L-2012-001  
10 CFR 52.3

Re: Florida Power & Light Company  
Proposed Turkey Point Units 6 and 7  
Docket Nos. 52-040 and 52-041  
Response to NRC Request for Additional Information Letter No. 041  
(eRAI 6024) SRP Section: 02.05.01 - Basic Geologic and Seismic Information

**NRC RAI Letter No. PTN-RAI-LTR-041**

**SRP Section: 02.05.01 - Basic Geologic and Seismic Information**

Figure 1 - Stratigraphic Cross Section Along the Florida Keys with More Than 150 meters in Relief on the Top of the Arcadia Formation (from a high of approximately 150 meters in W-12554 to a low of 300 meters in W-3174) (FSAR 2.5.1 Reference 373)

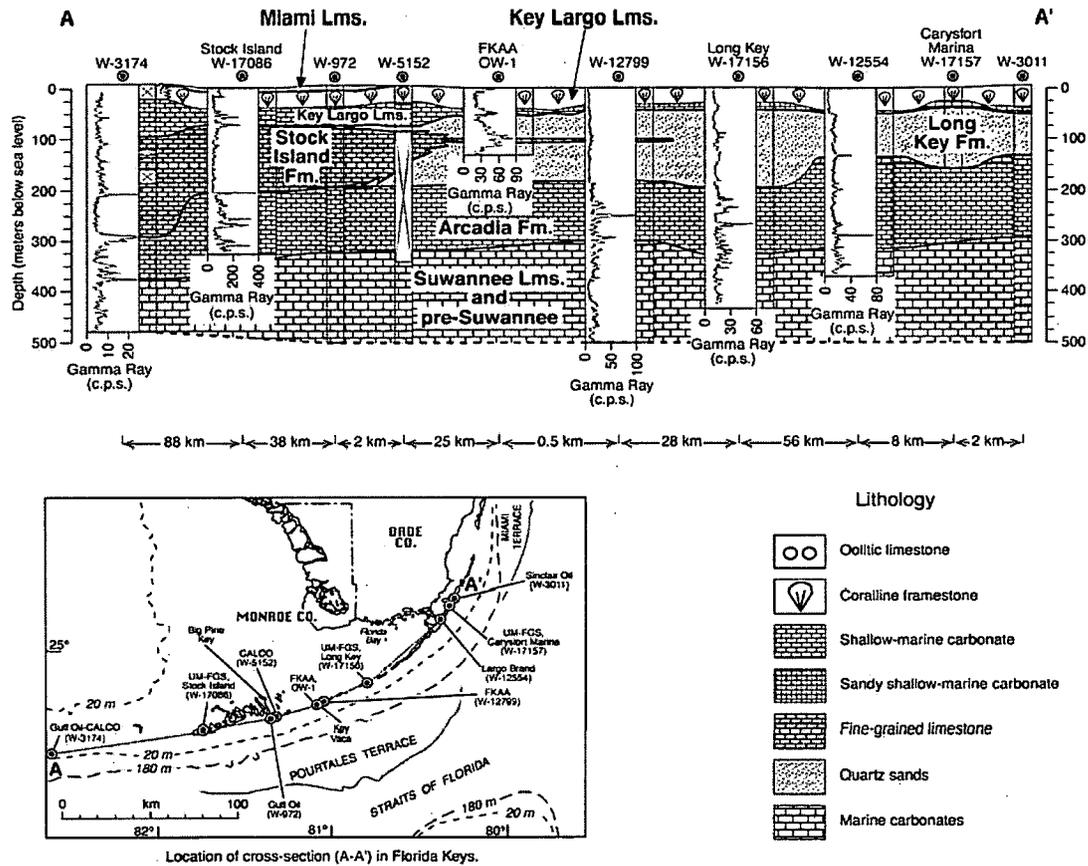
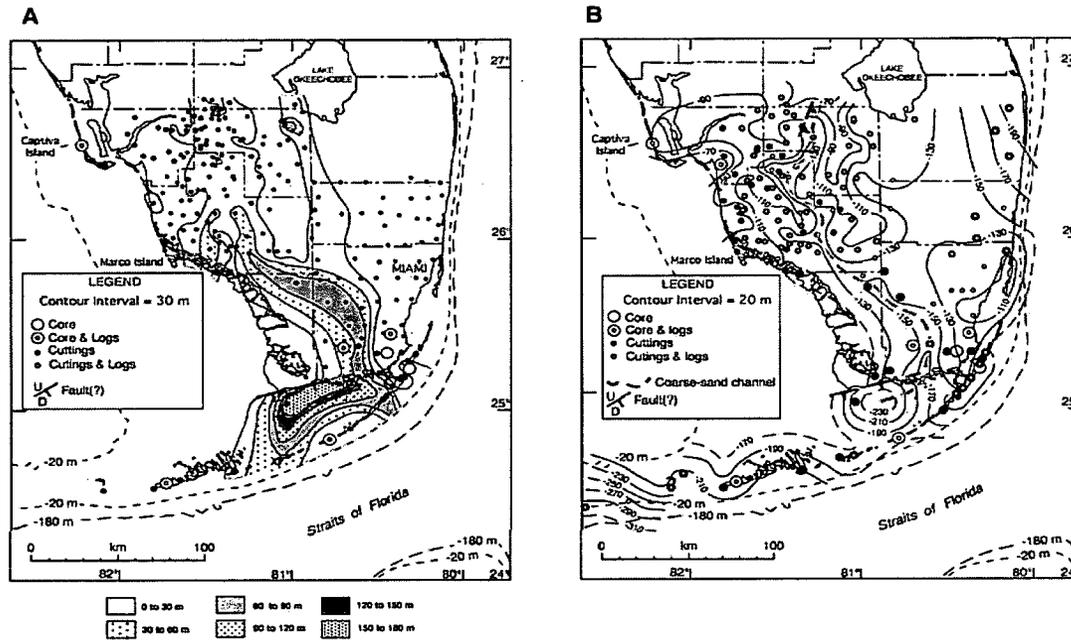
- a) Substantiate your interpretation with specific evidence that the stratigraphic relations across the queried fault shown in Figure 2.5.1-234 and depicted in Reference 373 are a result of paleo-topographic or karst processes, rather than tectonic offset.
- b) If the queried fault is indeed a fault, please discuss the timing and spatial extent of faulting and update the FSAR discussion accordingly.

a) Substantiate your interpretation with specific evidence that the stratigraphic relations across the queried fault shown in Figure 2.5.1-234 and depicted in Reference 373 are a result of paleo-topographic or karst processes, rather than tectonic offset.

The queried fault on FSAR Figure 2.6.1-234 was presumably interpreted because of the change in elevation of the Arcadia formation. However, because no discussion of the queried structure was presented in Cunningham et al. (1998) (FSAR 2.5.1 Reference 373, hereafter referred to as Cunningham et al. (1988)), it is uncertain if that assumption is correct. Nonetheless, the Everglades Park well W-2404 drilled the top of the Arcadia northeast of the queried fault at a depth of approximately 125 meters, while to the southwest the Gulf Oil well W-3510 drilled the top of the Arcadia at a depth of approximately 225 meters. FPL interpreted Figure 2.5.1-234 to indicate that in the Everglades Park well the Long Key formation is roughly 100 meters thick (though with an intervening limestone), while it is a little more than 125 meters thick in the Gulf well (also with intervening carbonates). FPL interprets a corresponding 25-30% increase in thickness across the queried structure.

The primary evidence that this approximately 100 meters of relief on the Arcadia could be related to paleotopography is that similar or greater amounts of relief are seen on the top of the Arcadia in southern Florida, without invoking tectonic faults (FSAR 2.5.1 Reference 373). In Cunningham et al's (1998) Figure 4, the top of the Arcadia formation varies by more than 150 meters in elevation, and by as much as 75 meters in adjacent wells (see Figure 1). The slope needed to accomplish the vertical offset seen between the Everglades Park and Gulf Oil well would only be 0.3°. This low slope is reasonable for normal sedimentary deposition in the region and the data do not require the interpretation of an intervening fault.

If the variation in elevation of the Arcadia formation is related to faulting, the relationships in Figure 2.5.1-234 indicate the fault is older in age than the Upper Miocene to Pliocene Long Key Formation. The queried depiction of this fault in Figure 17 of Cunningham et al. (1998) indicates that it could be as much as 55 km long. Since only two borings define the geometry of this fault, the uncertainties in the geometry of this structure are large. Farther east, closer to the Turkey Point site, boring data were not interpreted by Cunningham et al., (1988) as indicating the presence of a fault.

- The fault is queried in Cunningham et al (1998).
- No discussion of the reasoning for the queried structure are presented in Cunningham et al. (1998).
- The stratigraphy in the two wells that demarcate the potential fault was interpreted from cuttings only, no logs or core (see Figure 2).
- Recovery or available cuttings for the Arcadia formation in the Gulf well was apparently less than 20% (FSAR Figure 2.5.1-234).
- It appears that this fault is drawn on the basis of 2 wells in an area of very low well density (Figure 2).

Based upon the great uncertainties associated with this fault, the existence of this postulated structure is not substantiated by the available, albeit sparse, data.

**Figure 2.5.1-276 Seismic Line and Interpretation across the Walkers Cay Fault**

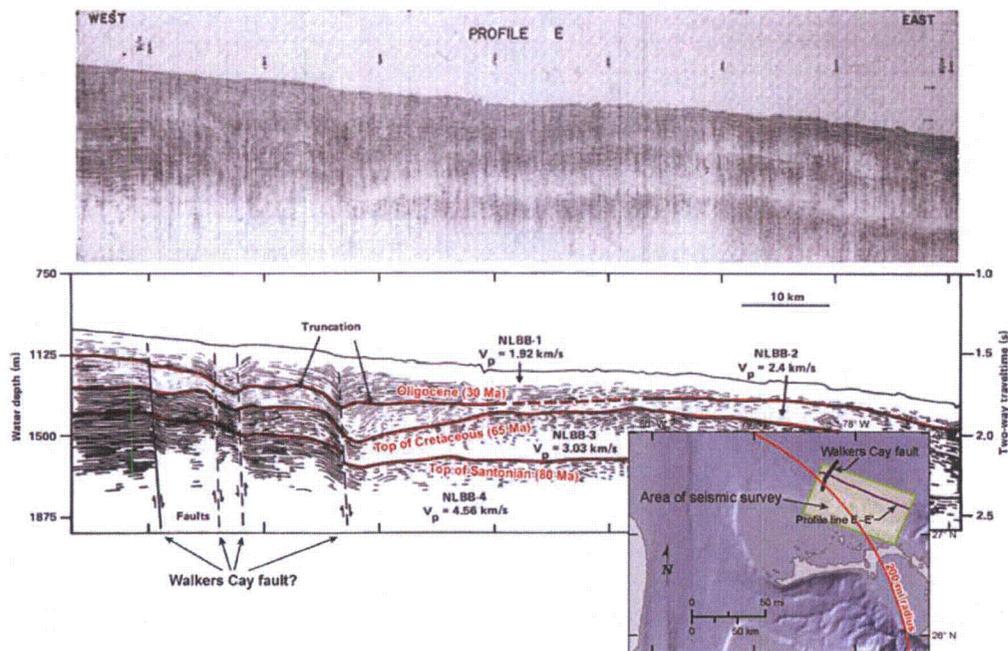
- 1) Label Walkers Cay fault on FSAR figure 2.5.1-276.
- 2) Explain the basis for Harwood and Towers (1988) conclusion within the limits of resolution for marine seismic reflection data.

1) Label Walkers Cay fault on FSAR figure 2.5.1-276

The interpreted faults on the seismic section of FSAR Figure 2.5.1-276 have been labeled on the revised Figure 2.5.1-276 shown in the Associated COLA Revisions section of this response. Labels requested as a part of RAI 02.05.01-18 have also been added.

FSAR Figure 2.5.1-276 will be replaced with the following revised figure in a future revision of the FSAR:

Figure 2.5.1-330 North America Stress Provinces

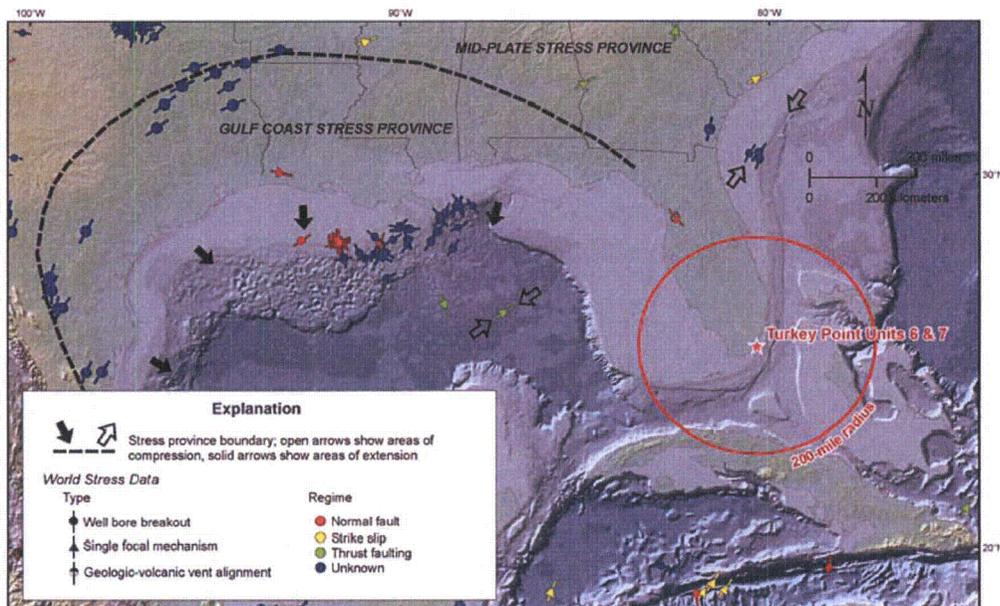
- a) Address the focal mechanism for the Sept 10, 2006 Gulf of Mexico earthquake with respect to the Gulf Coast stress province and show stress orientation indicated by this focal mechanism on Figure 2.5.1-330.
- b) Indicate on Figure 2.5.1-330 the boundary between the Gulf coast and mid plate stress provinces as it is currently interpreted within the TPNPP site region.
- c) Explain if analyses were performed to characterize the stress direction and magnitude in northern Cuba in light of the abundant seismicity along the northern parts of Cuba. Indicate on Figure 330 how the boundaries of the Gulf Coast and the mid plate stress provinces resolve in the vicinity of northern Cuba.

a) Address the focal mechanism for the Sept 10, 2006 Gulf of Mexico earthquake with respect to the Gulf Coast stress province and show stress orientation indicated by this focal mechanism on Figure 2.5.1-330.

b) Indicate on Figure 2.5.1-330 the boundary between the Gulf coast and mid plate stress provinces as it is currently interpreted within the TPNPP site region.

c) Explain if analyses were performed to characterize the stress direction and magnitude in northern Cuba in light of the abundant seismicity along the northern parts of Cuba. Indicate on Figure 330 how the boundaries of the Gulf Coast and the mid plate stress provinces resolve in the vicinity of northern Cuba.

As described in FSAR Subsections 2.5.2.4.3.1 and 2.5.2.4.3.2, the original EPRI-SOG source zones within the site region were updated to account for the September 10, 2006 Emb 5.90 Gulf of Mexico earthquake. Figure 2.5.1-330 has now been revised to also include the stress orientation from this event.

Figure 2.5.1-330 depicts the boundary between the Gulf Coast and mid-plate stress provinces as interpreted by Zoback and Zoback, 1991 (FSAR 2.5.1 Reference 705). We have not extended their stress boundary into the Florida Peninsula for two reasons. First, there is little stress data near the Florida Peninsula and Cuba that can be used to demarcate stress boundaries in this area. Second, the Florida Peninsula lacks the geologic features characteristic of the Gulf Coast stress province. Both of these points are discussed in Subsection 2.5.1.1.4 of the FSAR.

FSAR Figure 2.5.1-330 will be replaced with the revised figure shown below in a future revision of the FSAR:
